TYPE-NO CV 2100 - CV 3100	TYPE Coffee Vending Machines	T.I.-NO 02-2014				
COMPLAINT NO. -	SERIAL NUMBERS AFFECTED From and including SN 000000000000	ISSUED BY Documentation N&W Valbrembo				
SUBJECT New boiler insulator		ISSUED FOR (X): <table border="1"> <tr> <td>Action:</td> <td></td> </tr> <tr> <td>Information:</td> <td>x</td> </tr> </table>	Action:		Information:	x
Action:						
Information:	x

Fig. 1

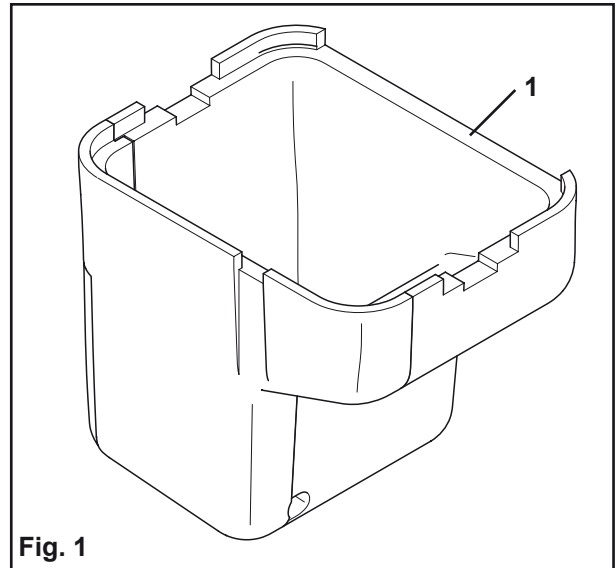
Part-No	Designation
previous, not installed from SN xxxxxxxxxxxx:	39759100	Boiler insulator
new, installed instead	257159	Boiler insulator (1, fig. 1)

From the above mentioned serial number on, a new boiler insulator is installed in dispensers of the types CV2100 and CV3100.
The new insulator is made of the material expanded polypropylene (EPP), which is according to testing procedures neutral in taste.

The new boiler insulator is installed in CV2100 and CV3100 to provide again the insulation function, after the dispensers were delivered without a boiler insulation for a short period of time: to provide a neutral beverage taste, the previous boiler insulator (39759100) made of EPS material was removed.

The new boiler insulator is made of the new material EPP, to avoid the risk of potential off-taste problems.

The new boiler insulator can be installed in all Cafitesse Coffee Vending Machines prior to the above mentioned serial number.
